Department of Energy
Washington, D.C. 20545

ADDITIONAL INFORMATION REGARDING PRELIMINARY SAFETY ANALYSIS REPORT (PSAR)
CHAPTER 4 "REACTOR" ON THE CLINCH RIVER BREEDER REACTOR PLANT

Reference: Letter HQ:S:82:139, J. R. Longenecker to P. S. Check, "Reactor
Design (Chapter 4) Working Meeting, November 25 and 26, 1982 -
Additional Information," dated December 6, 1982

FIG. 1: VARIATION OF MAXIMUM CLADDING TEMPERATURE WITH TIME SINCE REACTOR SHUTDOWN FOR REFUELING ACCIDENT.

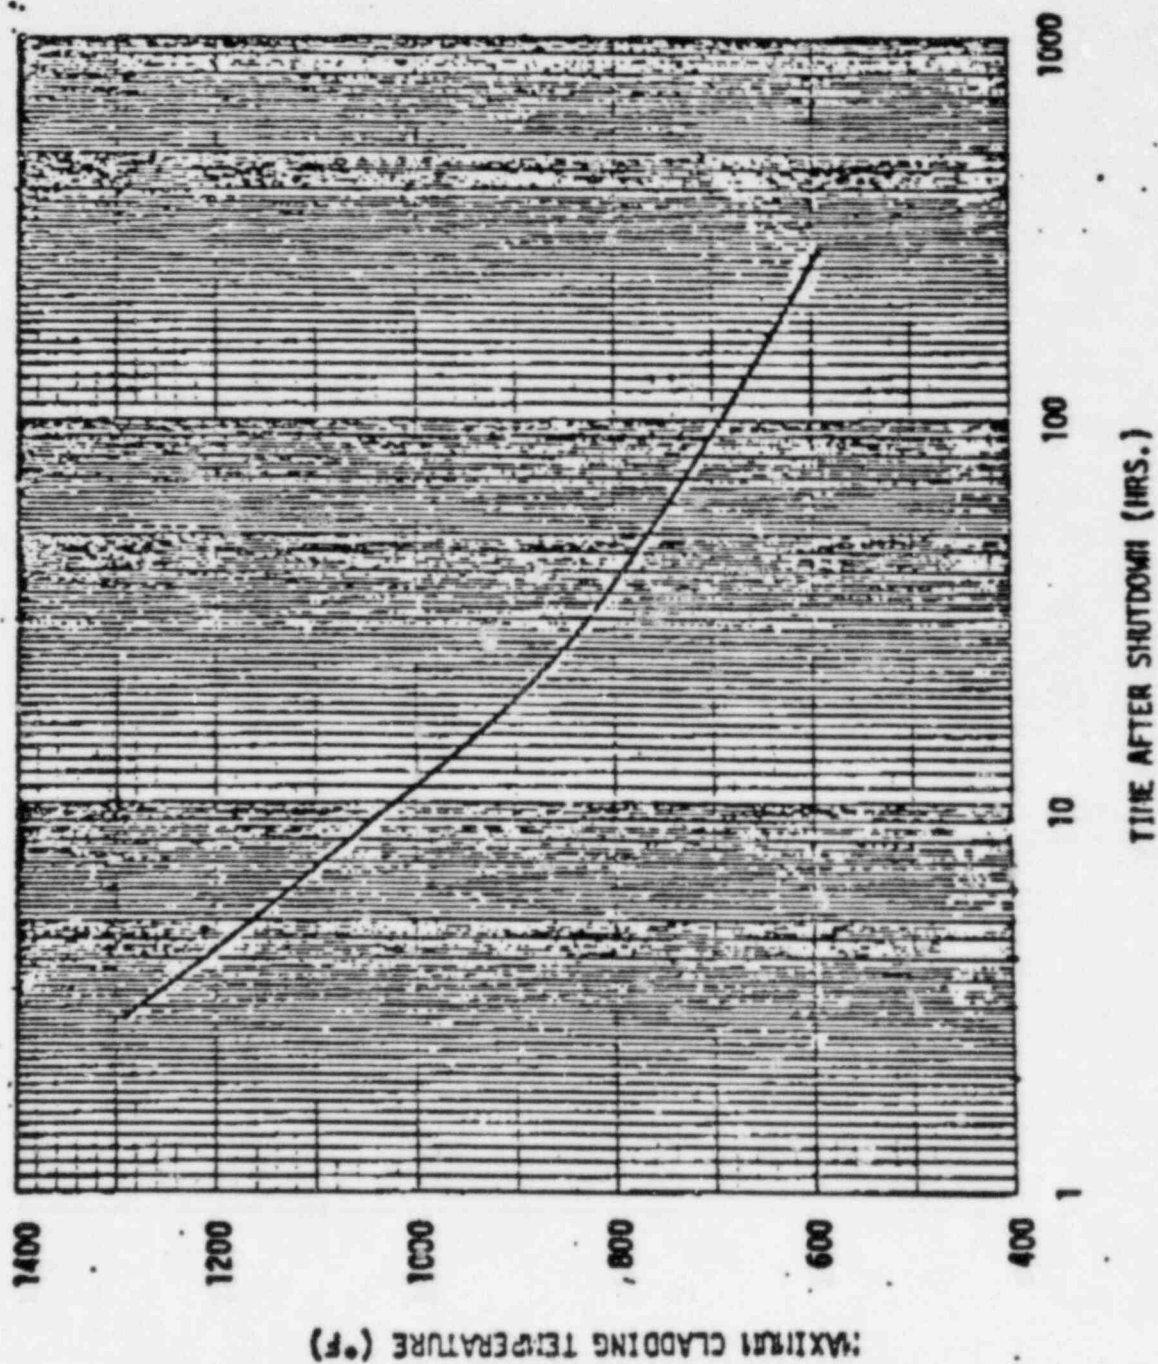
Describe design features to prevent core assembly outlet flow blockages.

The applicant will provide the NRC with the results of an analysis which demonstrates that should a total blockage of an assembly outlet nozzle occur six hours after shut-down, no significant assembly degradation will result.

An analysis was performed to determine the maximum cladding temperature due to complete blockage of a fuel assembly outlet nozzle during refueling. It was found that, even using a conservative analysis, the maximum cladding temperature for this accident (if it occurs after 6 hours from shutdown) would be less than that for operating conditions.

Figure 1 shows the maximum cladding temperature (i.e., for center pin) as a function of time from shutdown for the accident occurring. Typically, refueling would not be expected to start in less than two days from shutdown. However, earlier times are shown on the figure for parametric purposes. It can be noted that even at six hours from shutdown, the maximum temperature would be less

than 1125°F(*). The steady state, 30 inner cladding temperature for the hot rod at operating conditions is larger than this value, and therefore, it would be expected that this accident condition would cause an insignificant increase in cladding damage.
